City of Columbia

Municipal Planning Commission

December 8, 2021

RE: Response to Technical Review Comments
Item No. 21-0205
1451 Lasea Road
Preliminary PUD Master Plan

PRELIMINARY MASTER DEVELOPMENT PLAN-LASEA TOWNHOMES

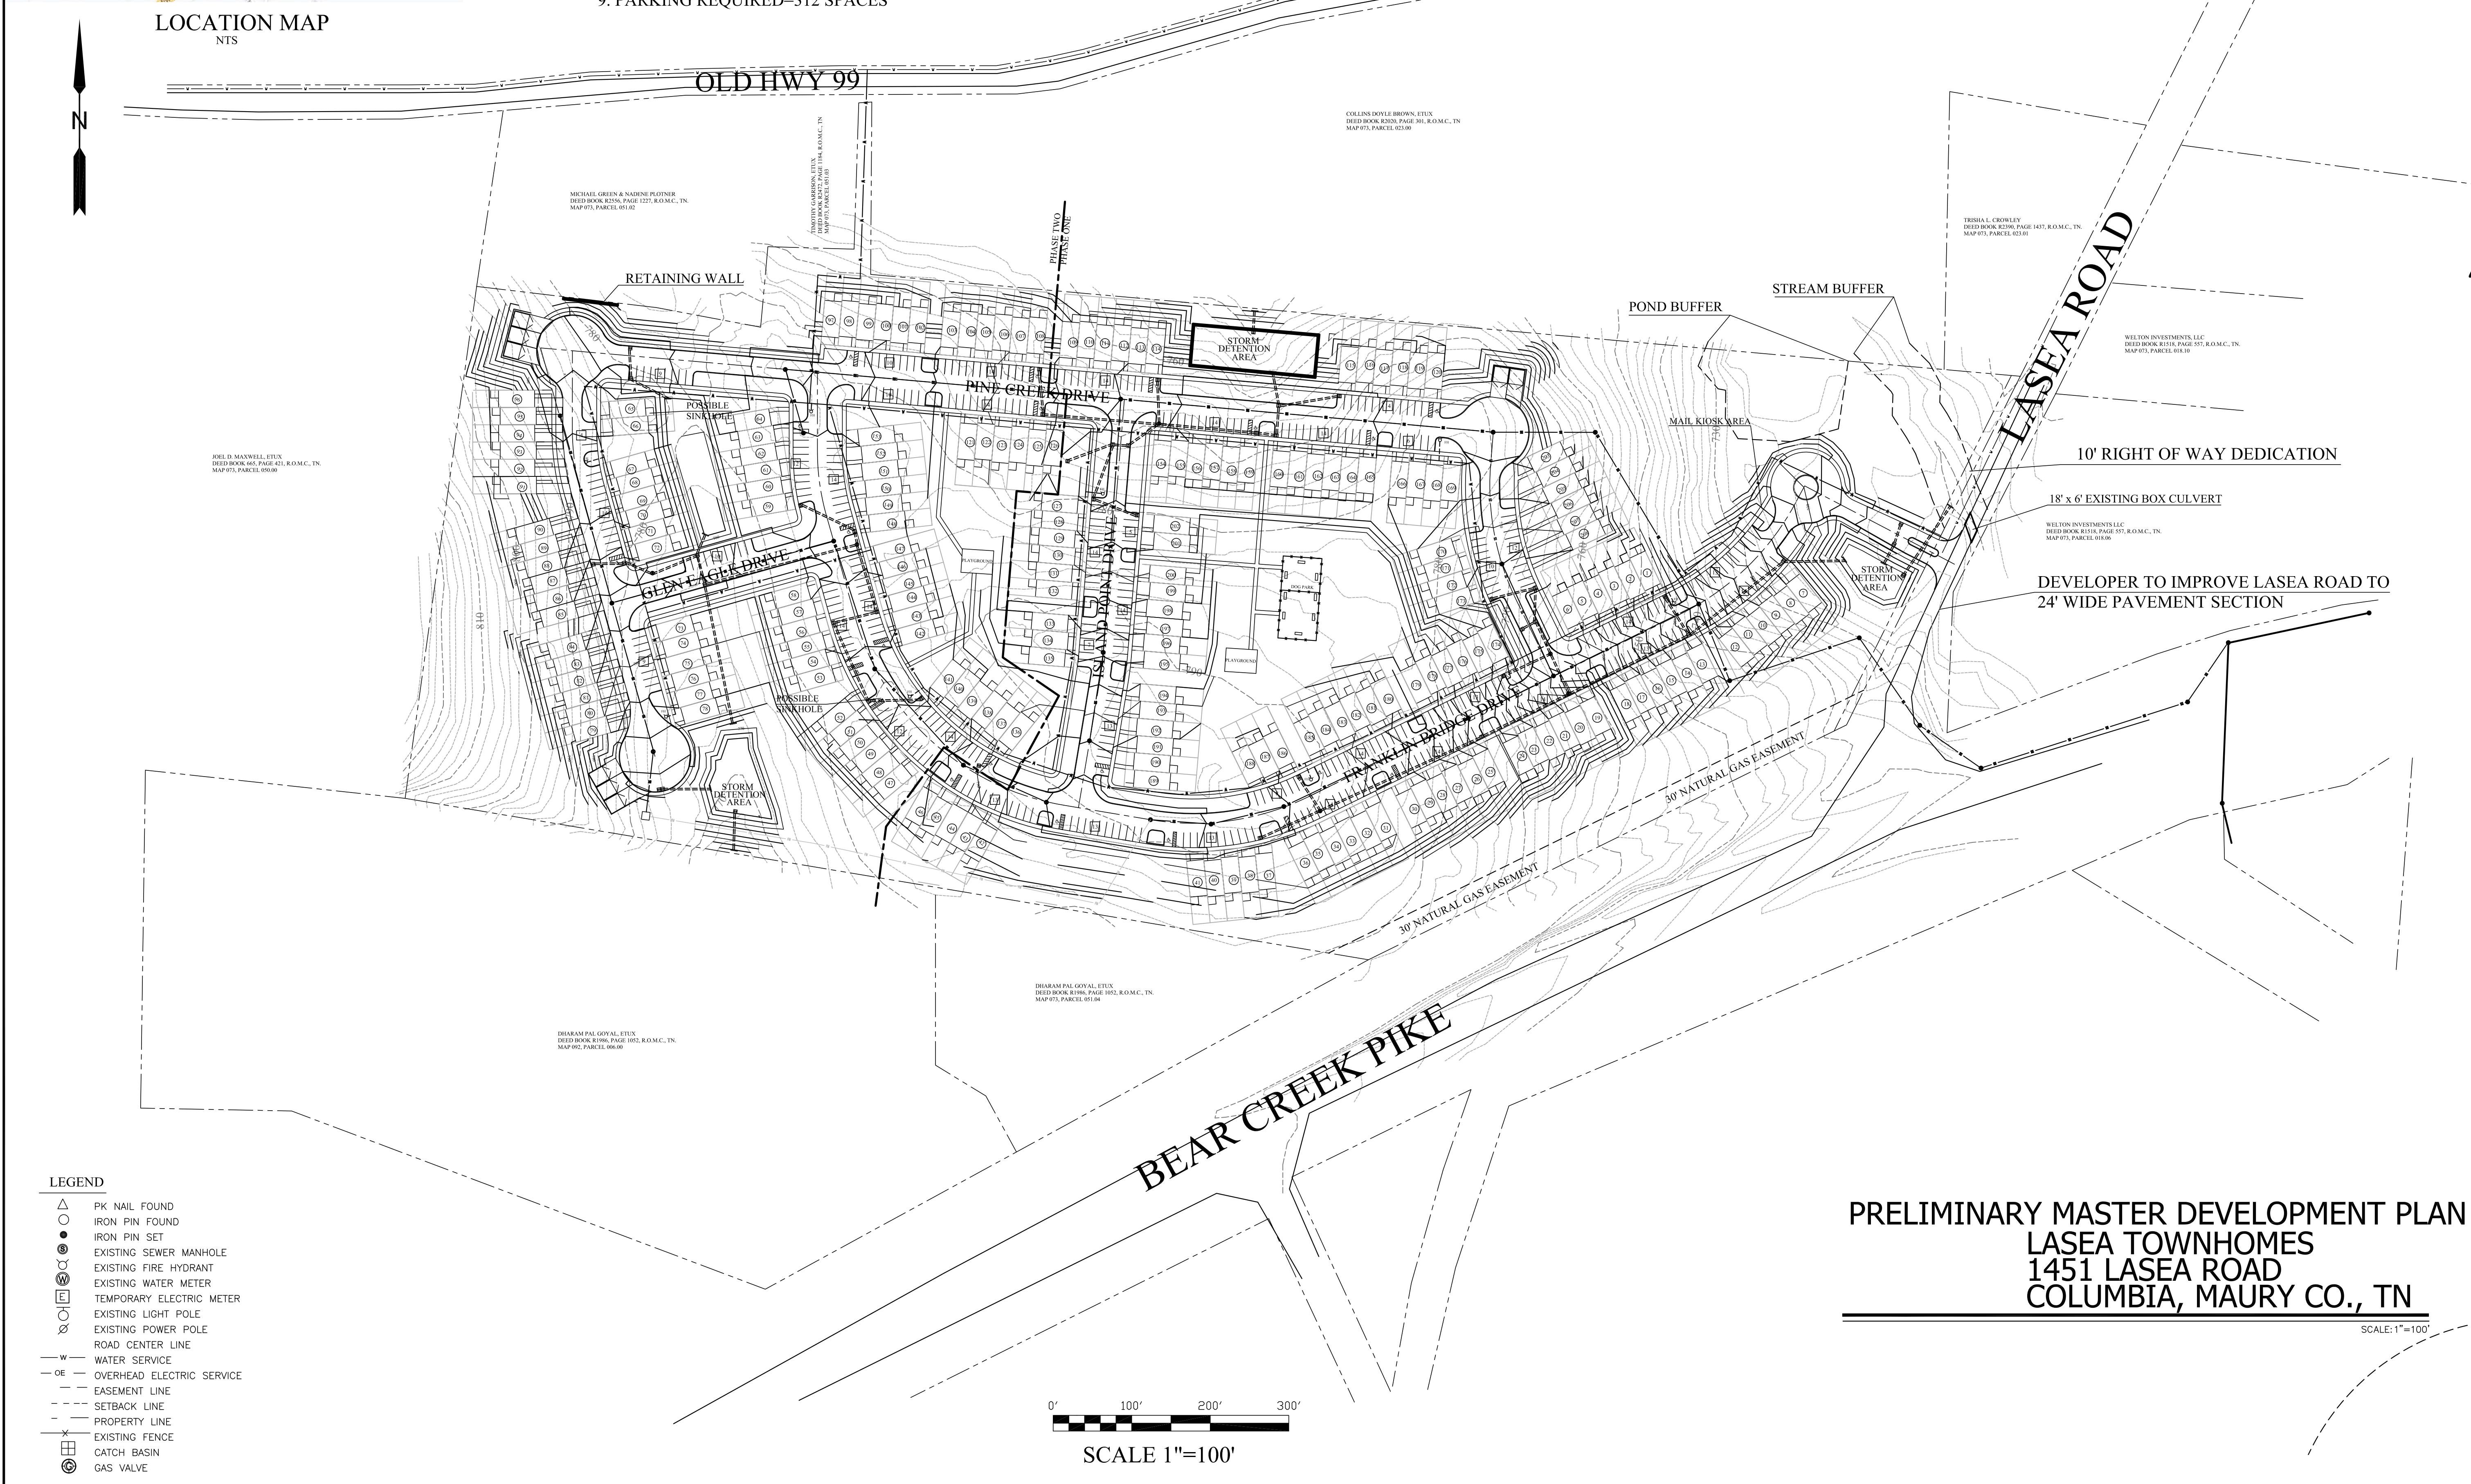
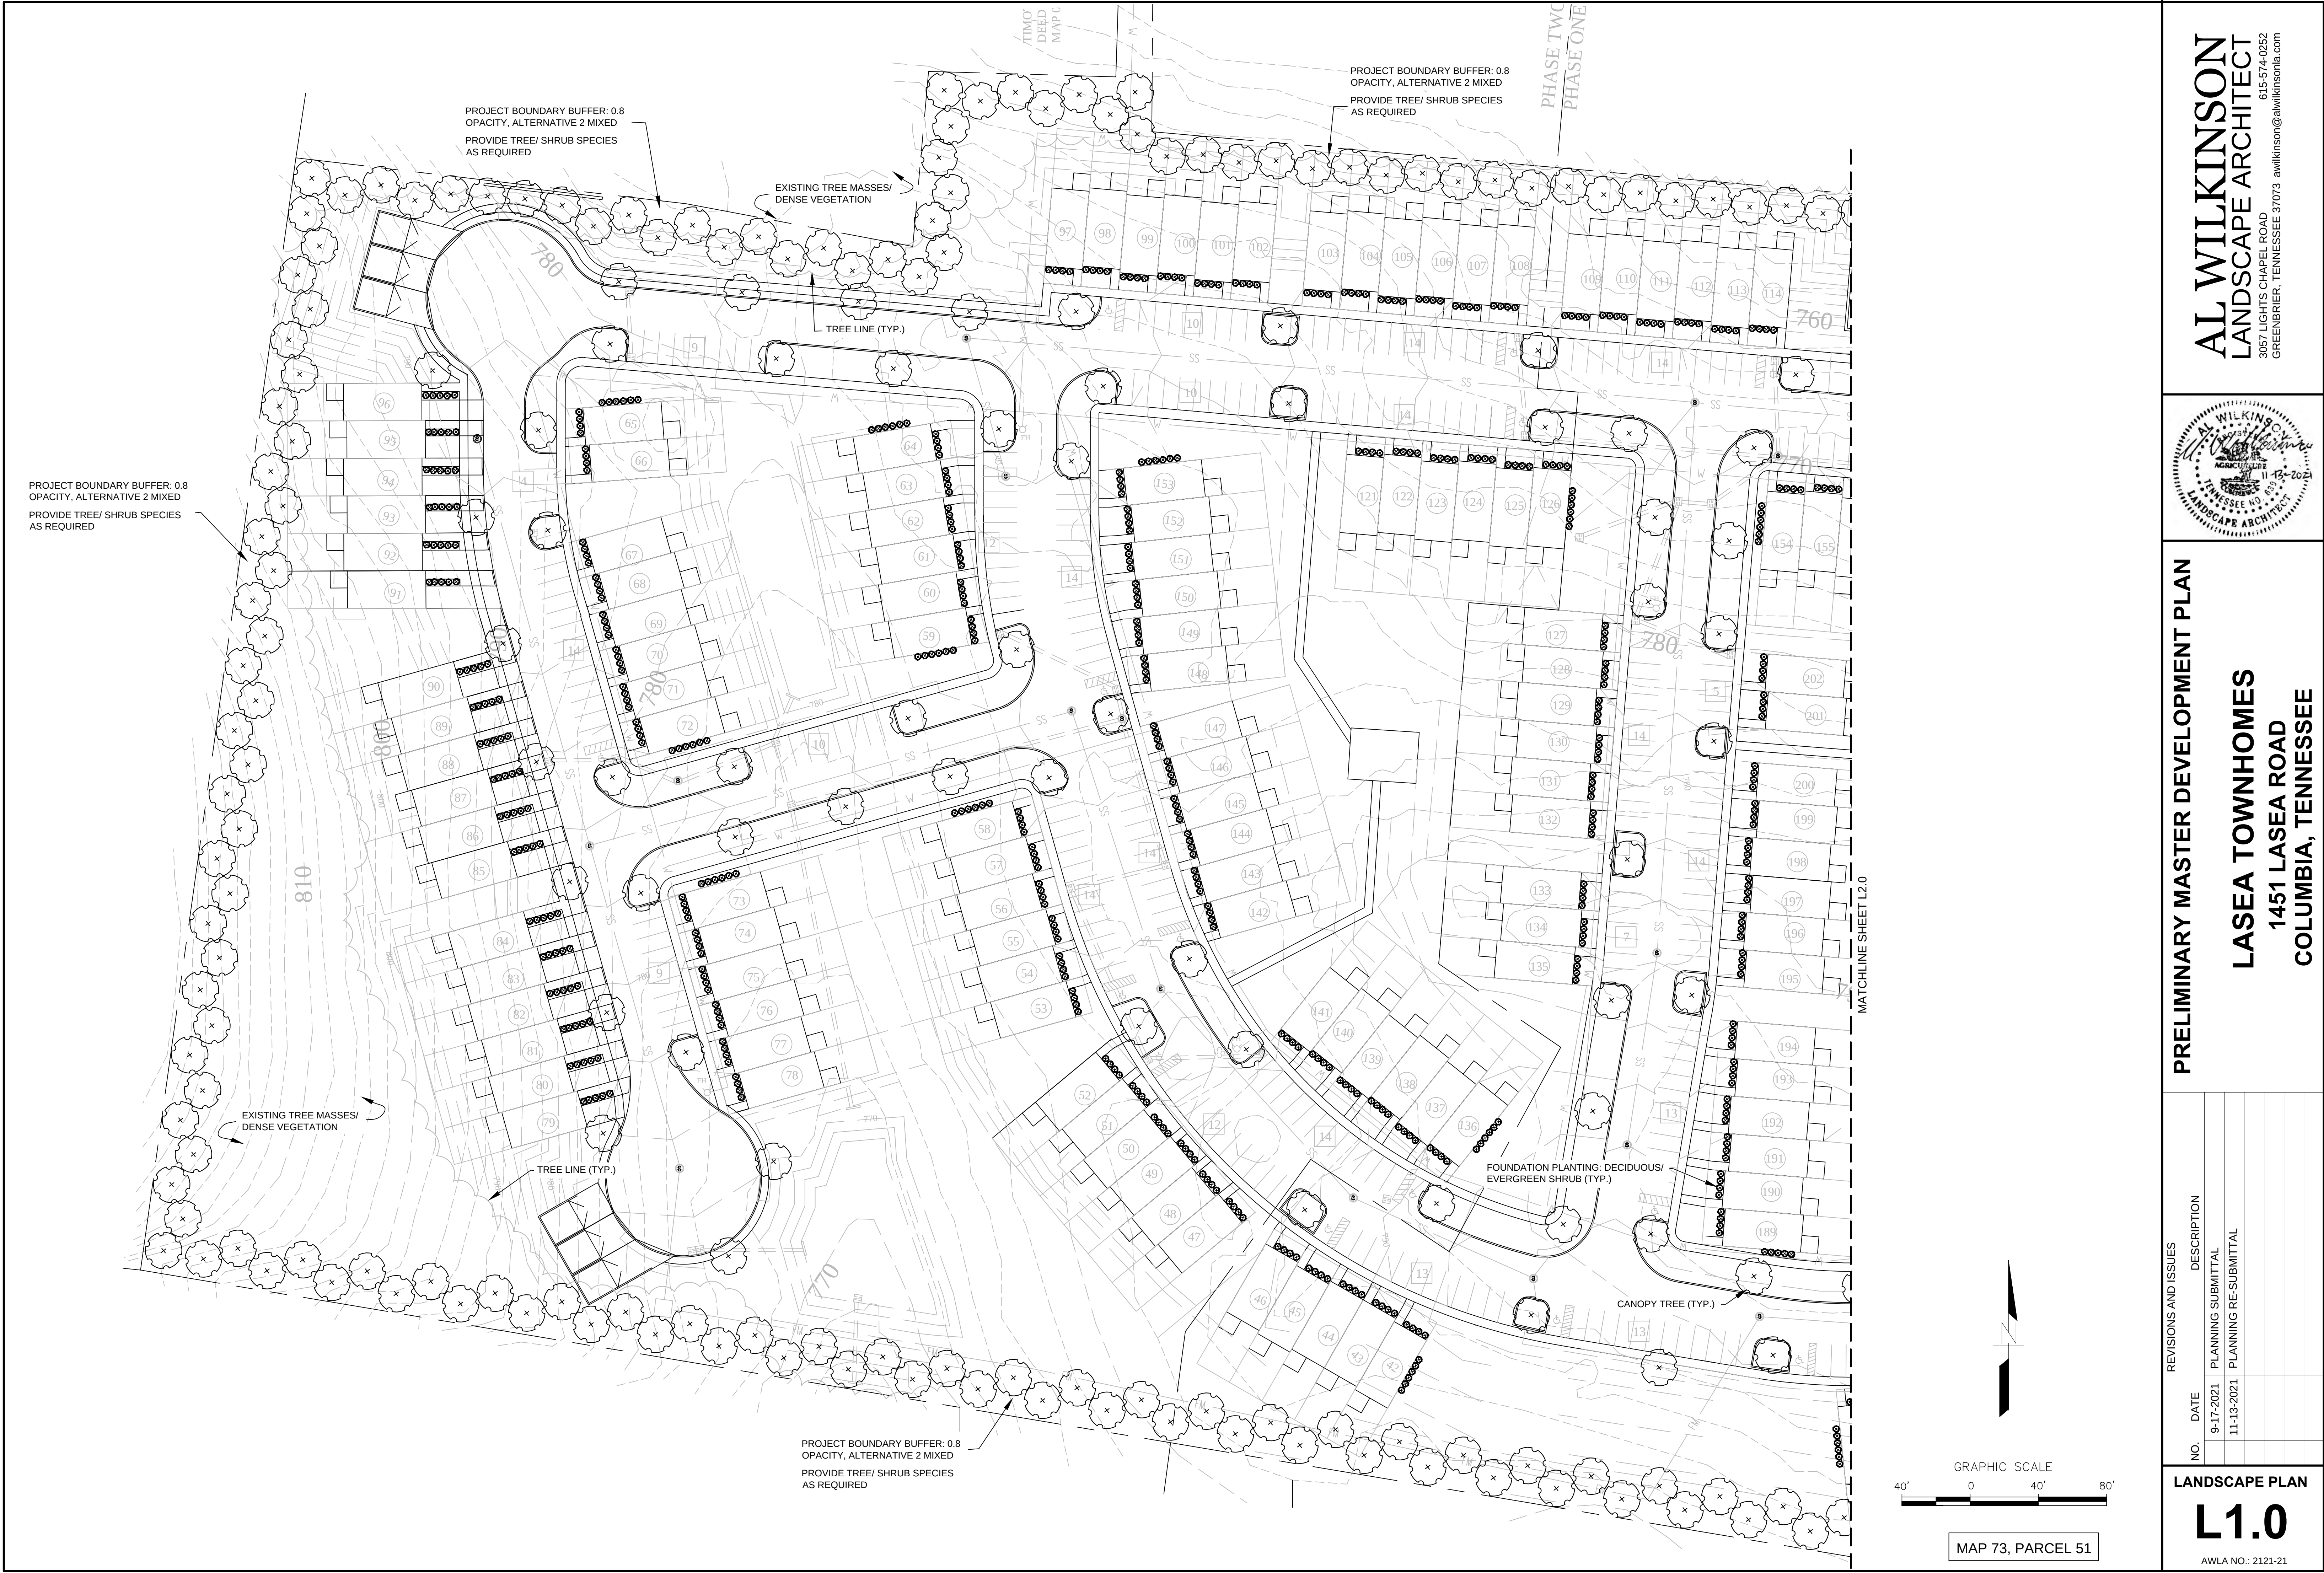
3. Private sanitation services are an option for townhomes, or our department can service them via dumpster service. For 208 townhomes, we recommend four (4) 8-yard dumpsters serviced 4 days a week. I only see 2 dumpsters enclosures/pads on the preliminary master development plan. Two dumpsters are not enough for 208 units. Please see attached dumpster guidelines and accessibility requirements. Note: The proposed dumpster location in the northeast cul-de-sac with the island will prove to be a clearance and accessibility issue for front load trucks attempting to service this dumpster enclosure. Please remove the island to remove clearance and accessibility issues. Thank you!

15. Stormwater detention areas appear small for the amount of impervious area.
16. Provide location and size of existing box culvert underneath Lasea Rd.

18. Provide hydrologic determination on pond.
19. ARAP permit will be required for creek crossing and culvert.
20. Show all aquatic resource buffers. Pumpkin Creek is evaluated as an Exceptional Resource. HUC #06040002

21. Show existing sinkhole/depression locations.

34. Lots 7-36 that have a rear facing facade facing Bear Creek should provide a detailed plan to screen or use a linear park area amenity.
35. Lots 37-44 shall face a drive or street

36. Building Elevations lack detail of all sides and materials, plans refer to a basement building elevation but not shown
37. Of the 208 units proposed 190 are of the same facade, would recommend providing some variation

39. Parking lot lighting areas with photometric required at construction plan stage.
40. Lots 79-96 are missing the sidewalk
41. This is abutting a very rural area on two sides and overall would recommend spacing and building types to blend into the adjacent properties.

3. Private sanitation services are an option for townhomes, or our department can service them via dumpster service. For 208 townhomes, we recommend four (4) 8-yard dumpsters serviced 4 days a week. I only see 2 dumpsters enclosures/pads on the preliminary master development plan. Two dumpsters are not enough for 208 units. Please see attached dumpster guidelines and accessibility requirements. Note: The proposed dumpster location in the northeast cul-de-sac with the island will prove to be a clearance and accessibility issue for front load trucks attempting to service this dumpster enclosure. Please remove the island to remove clearance and accessibility issues. Thank you!

Note: we have added six additional dumpsters with concrete pads and enclosures

15. Stormwater detention areas appear small for the amount of impervious area. Note we have enlarged them.
16. Provide location and size of existing box culvert underneath Lasea Rd. Provided

18. Provide hydrologic determination on pond. Will be provided during construction drawing phase
19. ARAP permit will be required for creek crossing and culvert. We have moved the entrance to protect the stream and provide buffers

20. Show all aquatic resource buffers. Pumpkin Creek is evaluated as an Exceptional Resource. HUC #06040002 We have provided a stream buffer and moved the entrance to protect the stream

21. Show existing sinkhole/depression locations. Possible sinkholes shown
22. Maximum grade for drives is 10%. Grades over 10% have been eliminate
23. Maximum grade for parking stalls is 8% Maximum grades in parking areas is no less than or equal to 8%

26. Intersections shall skew no more than 20 degrees from 90 degrees. Intersections have been revised
27. City requests a dedication of ROW along the property frontage on Lasea Rd. A minimum of 35' from the centerline of the road. 10' dedication provided

33. Landscape buffers are missing on several property lines, overall the buffer area should be reviewed for compliance and additional spacing for areas to help blend high density to rural. Buffers provided
34. Lots 7-36 that have a rear facing facade facing Bear Creek should provide a detailed plan to screen or use a linear park area amenity. Screen provided
35. Lots 37-44 shall face a drive or street Revised

- 36. Building Elevations lack detail of all sides and materials, plans refer to a basement building elevation but not shown Provided
- 37. Of the 208 units proposed 190 are of the same facade, would recommend providing some variation Provided
- 38. Show details of the amenities, address playground with no access, and overall area looks small for number of units and location to public facilities. Details provided
- 39. Parking lot lighting areas with photometric required at construction plan stage. Acknowledged
- 40. lots 79-96 are missing the sidewalk Added
- 41. This is abutting a very rural area on two sides and overall would recommend spacing and building types to blend into the adjacent properties. Buffers provided
